The Columbia Architectural Design Review Team will meet on Tuesday, March 7, 2023 at 9:00 AM in Conference Room A on the basement level of City Hall, 700 N. Garden Street. The Planning Commission will consider the following:

1. Case #22-0329 Request from Cole Murphy for facade approval of new townhome construction off Honey Farm Way being a portion of [Tax Map 51 Parcel 58](#).

ART 22-0329

2248 Nashville Highway (Honey Farms Planned Unit Development)/ Tax Map 051 Parcel 058

PLANNING STAFF EVALUATION:

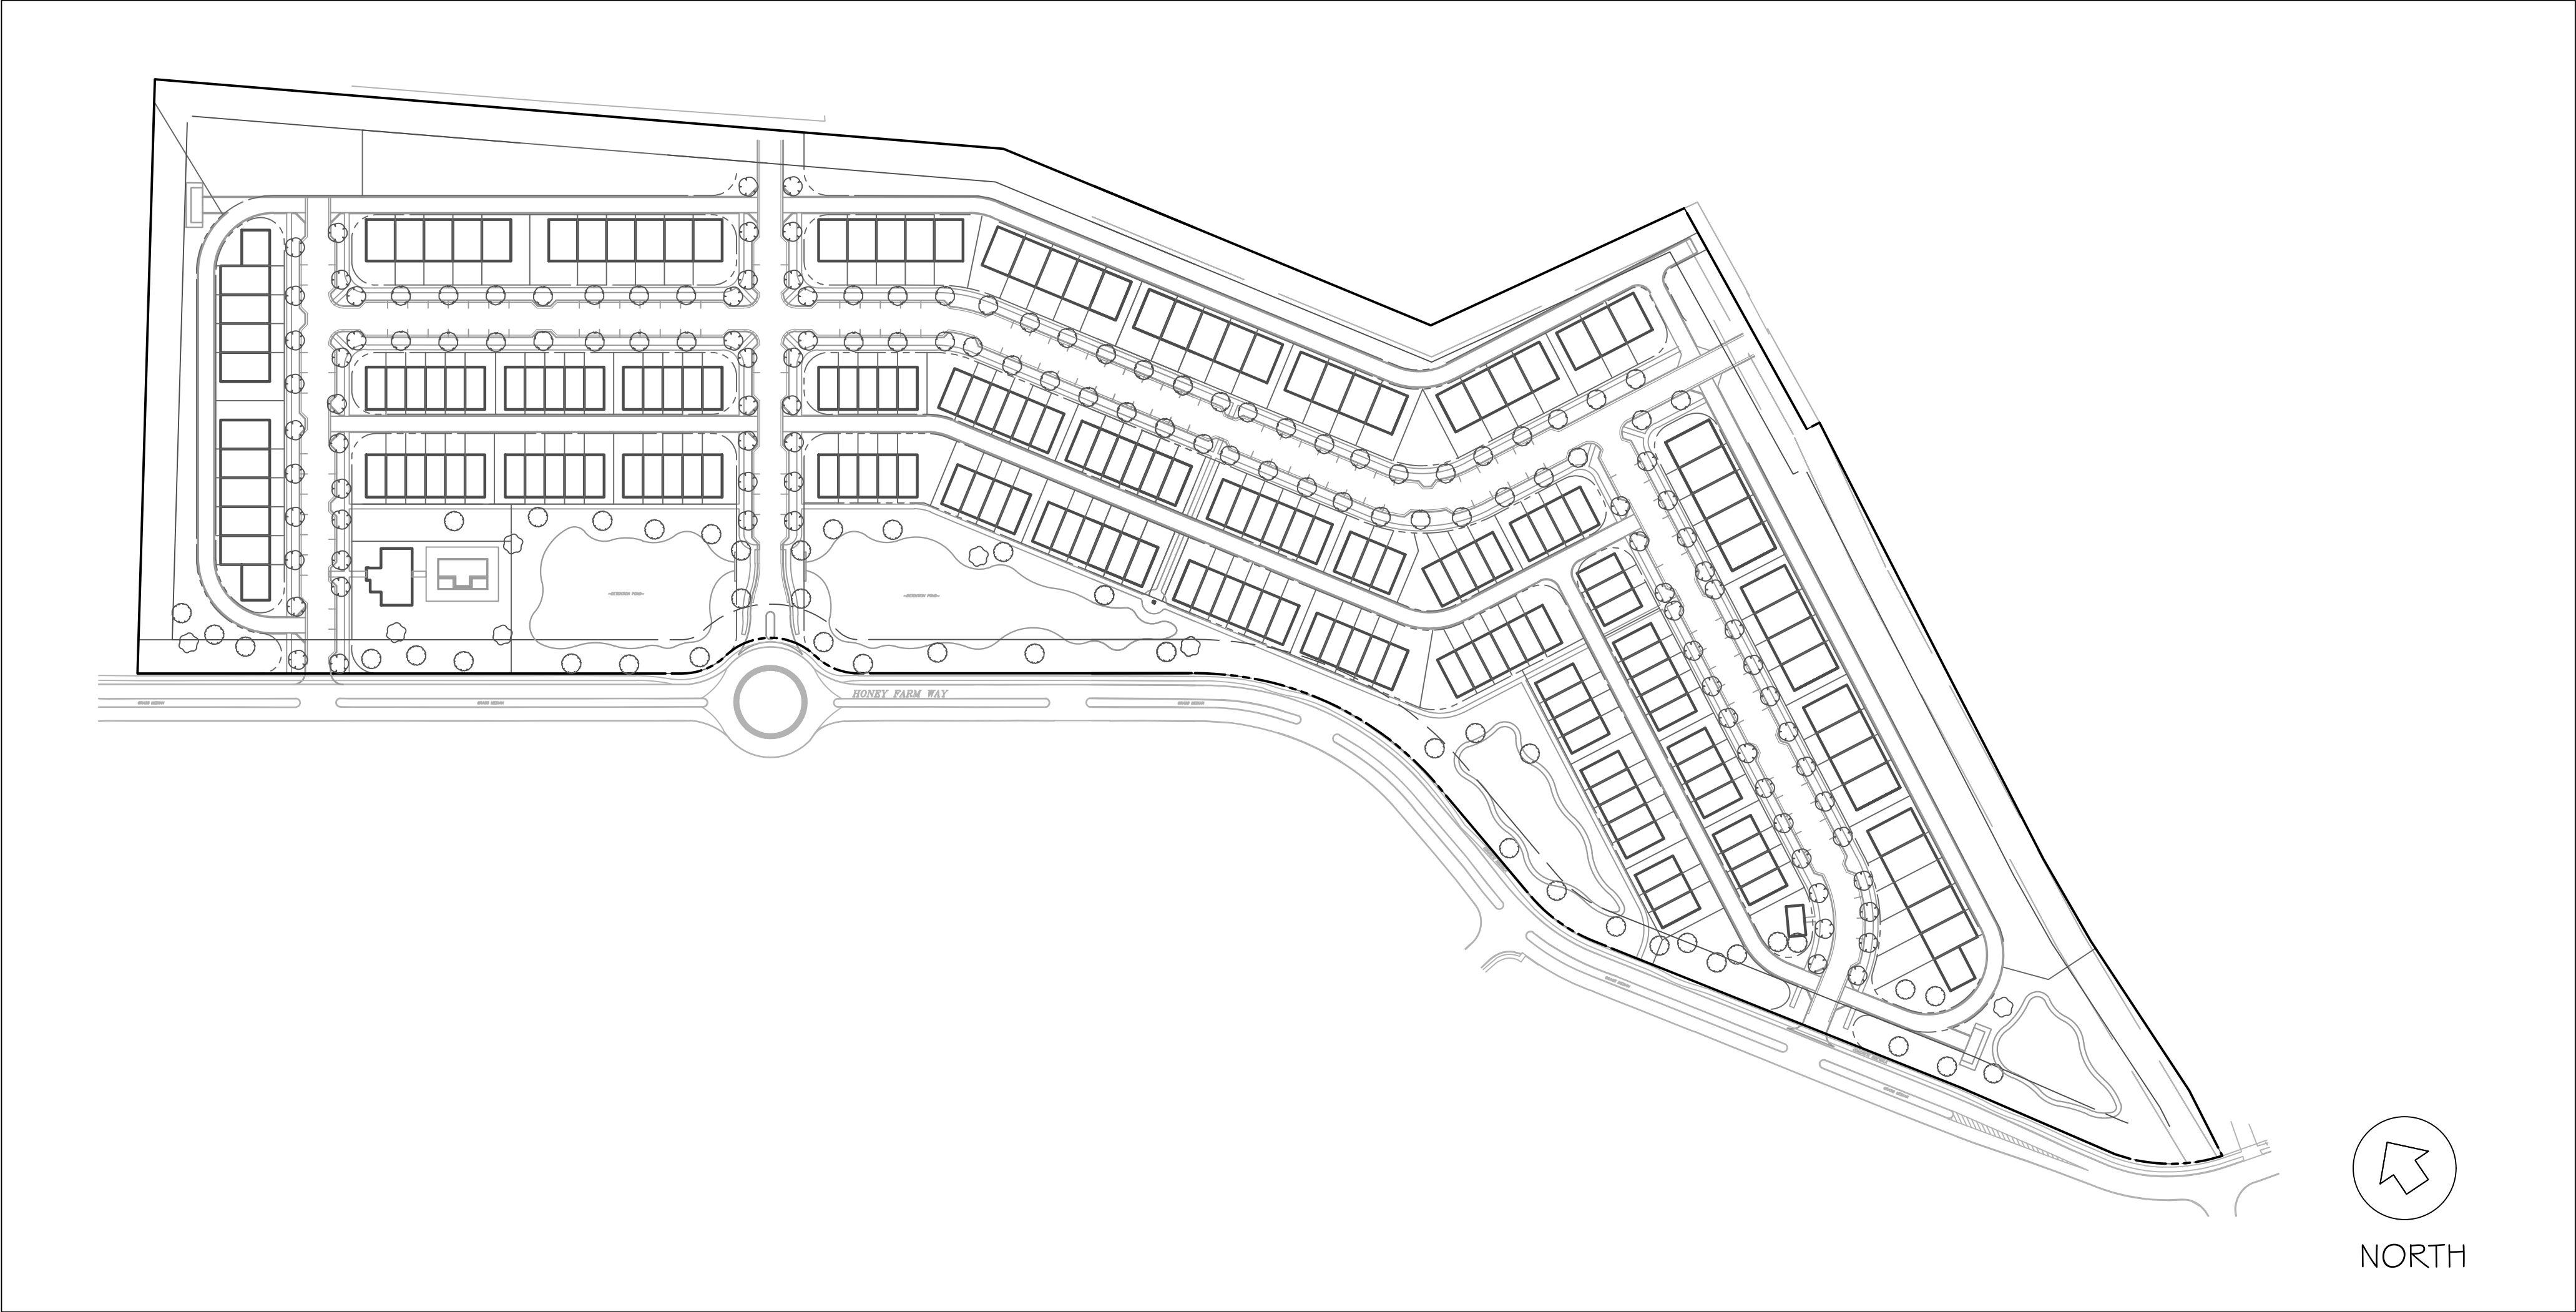
- Primary building materials on façade consist of cementitious siding and brick that are permitted materials on primary building facades.
- Façade articulation is required for a façade greater than 100'. The applicant has selected to achieve this articulation with the use of multiple colors with a material change including a variation among columns, window types, and door designs.

- All elevations require a foundation cladding of brick or natural stone. These details shall be shown on all elevations. This would achieve the building composition requirement of having a defined base, middle, and cap.

- Garage design is required to contain carriage house style doors with a garage door width of 9ft and each garage door having ornamental lighting above it. Garage design does not indicate ornamental lighting fixtures with carriage house style doors with door widths that exceed 9ft. In addition, garages units are required to be at least 10 X 20 for one stall. Floor plan details do not indicate the size of the garage unit as required per the code.

- Window trim details required for top plate if fiber cement board surrounds window; or soldier course above lintel and rowlock course below sill for brick elevations. Elevations that contain brick show a rowlock course below sill, and trim around the windows where Cementous siding is used.

- Indicate details that show minimum 6' clear depth for porch frontages. As discussed at our previous meeting, stoops are accepted for primary façade entry; however, if porches are utilized than they require at least a 6' clear depth to be shown.

- Façade variety is indicated as being broken up by color, noting that no more than one façade shall be on the same block face or within view of the same façade. Applicant has submitted a pattern book indicating how facades will be broken up from block face and view; however, this pattern book only shows the western section of the property with the remainder of the master site plan omitted and not shown.

- Details shall be given regarding porch pier cladding indicating brick or natural stone. Applicant has submitted a porch column design sheet showing column variety include composite wrapped and white pine with options for a brick base and a column option with a tapered design and brick base.

PLANNING STAFF EVALUATION:

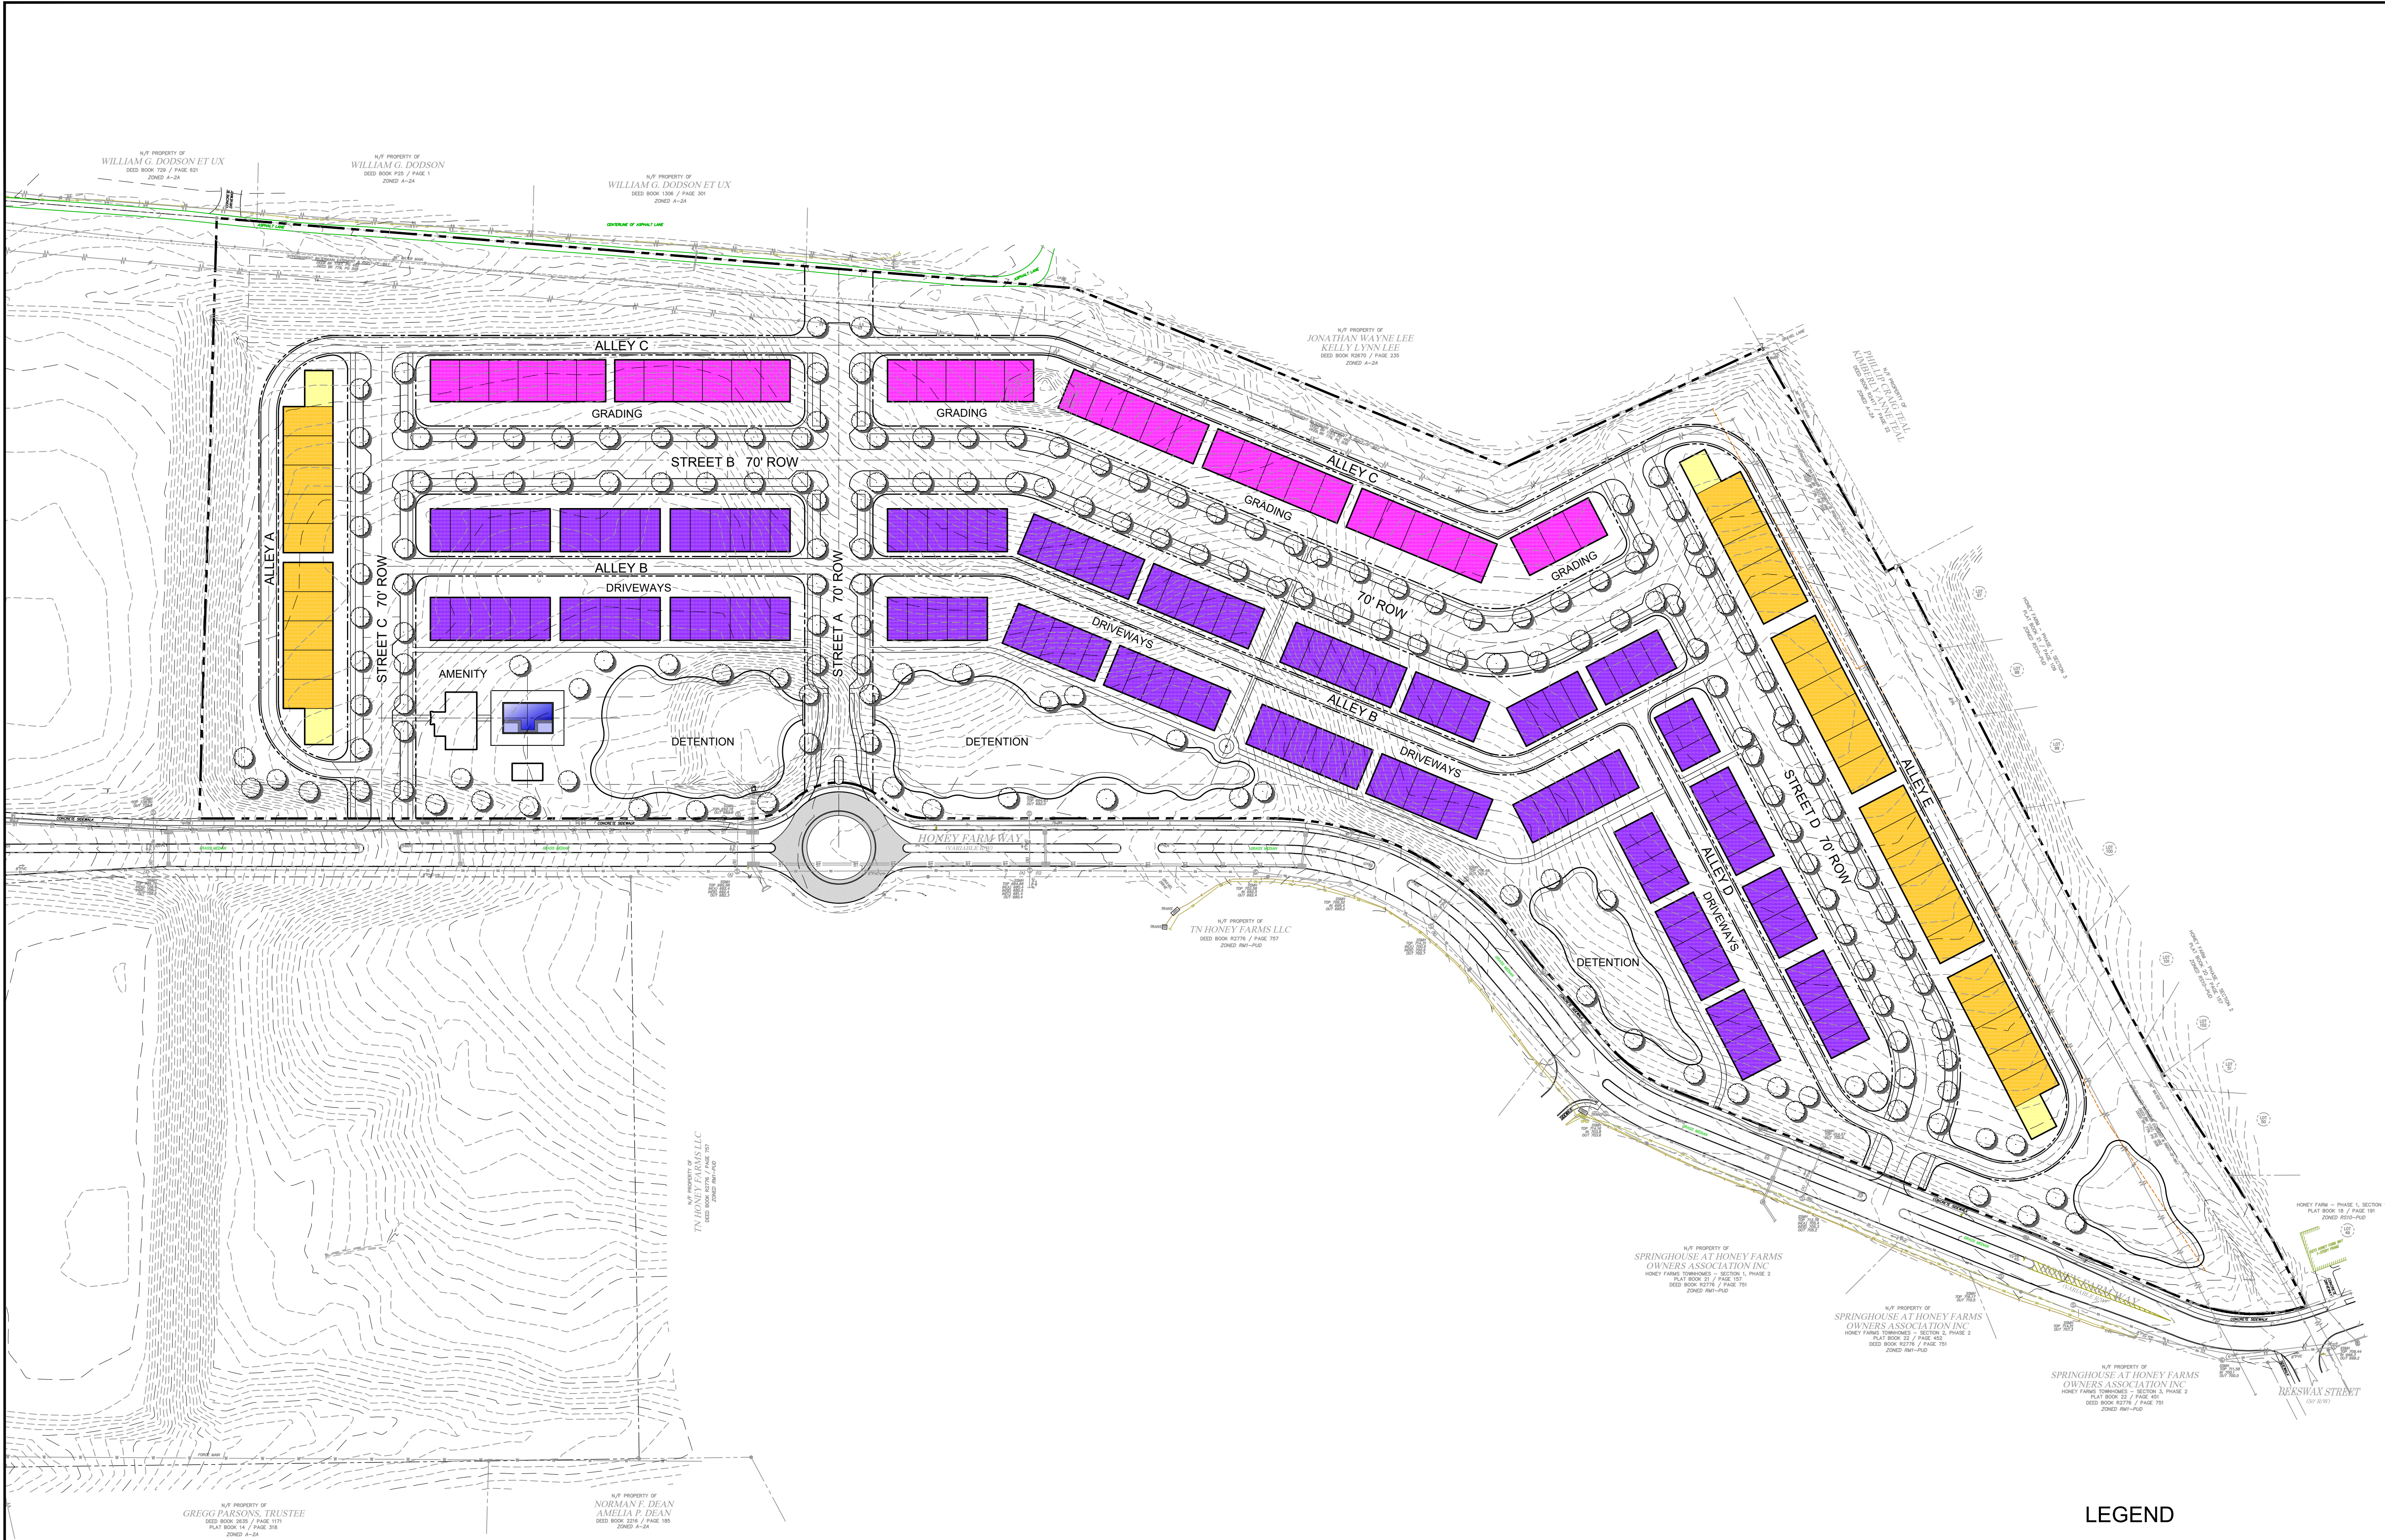
- Primary building materials on façade consist of cementitious siding and brick that are permitted materials on primary building facades.
- Façade articulation is required for a façade greater than 100'. The applicant has selected to achieve this articulation with the use of multiple colors with a material change of a combination of fiber cement board and white brick.

- Indicate details that show minimum 6' clear depth for porch frontages.
- Façade variety is indicated as being broken up by color, noting that no more than one façade shall be on the same block face or within view of the same façade.

PLANNING STAFF EVALUATION:

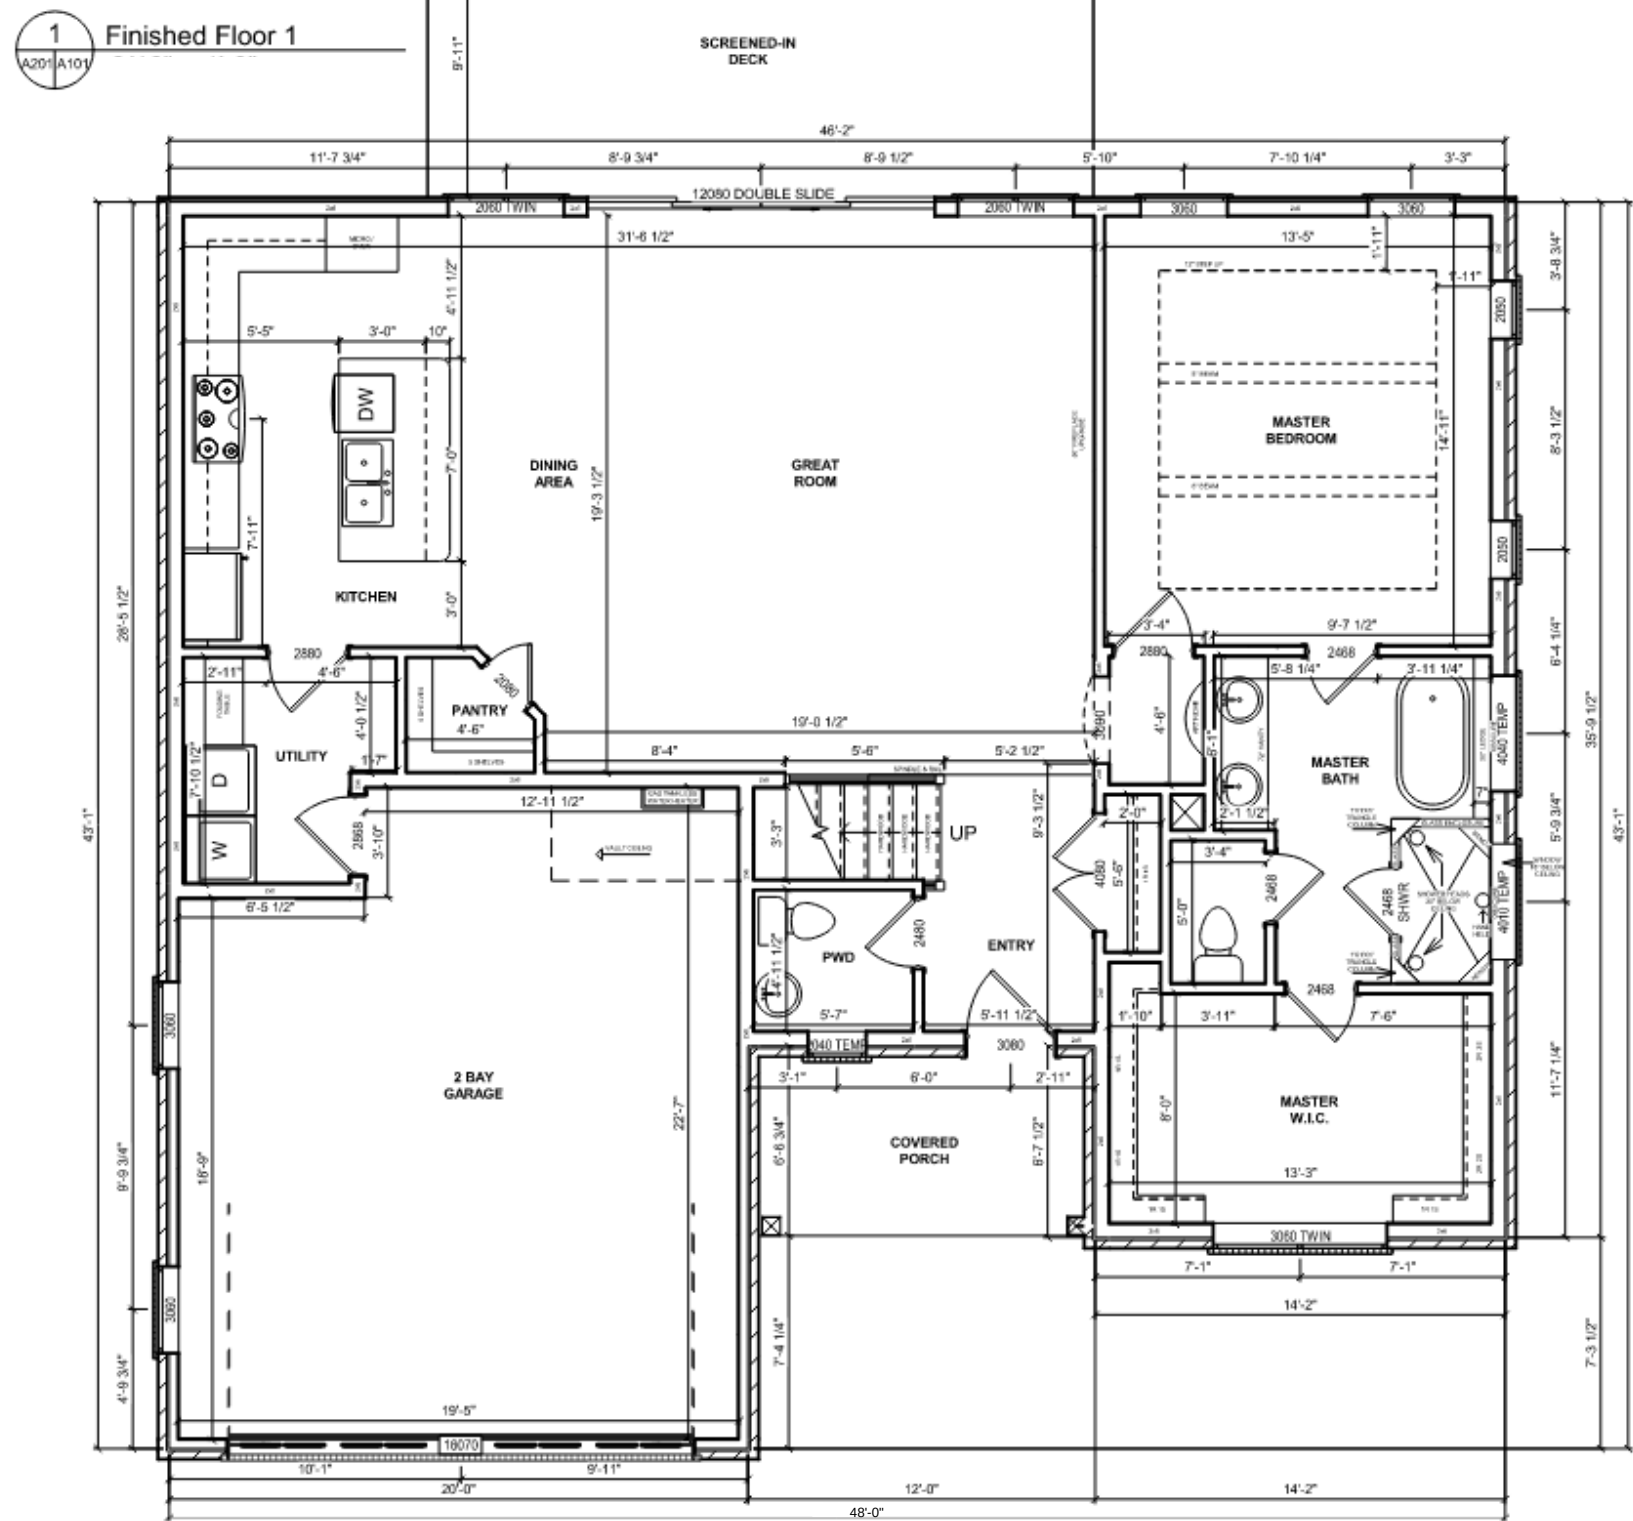
- Primary building materials on single-family home façade consist of cementitious siding, brick, and stone that are permitted materials on primary house facades.

- Elevations require a foundation cladding of brick or natural stone. All elevations include indicate this foundation cladding requirement.
- Garage design is required to contain carriage house style doors with a garage door width of 9ft and each garage door having ornamental lighting above it. Garage design for all elevations indicate a garage door with of 9 ft. or less with an ornamental lighting fixture when including carriage house style doors.
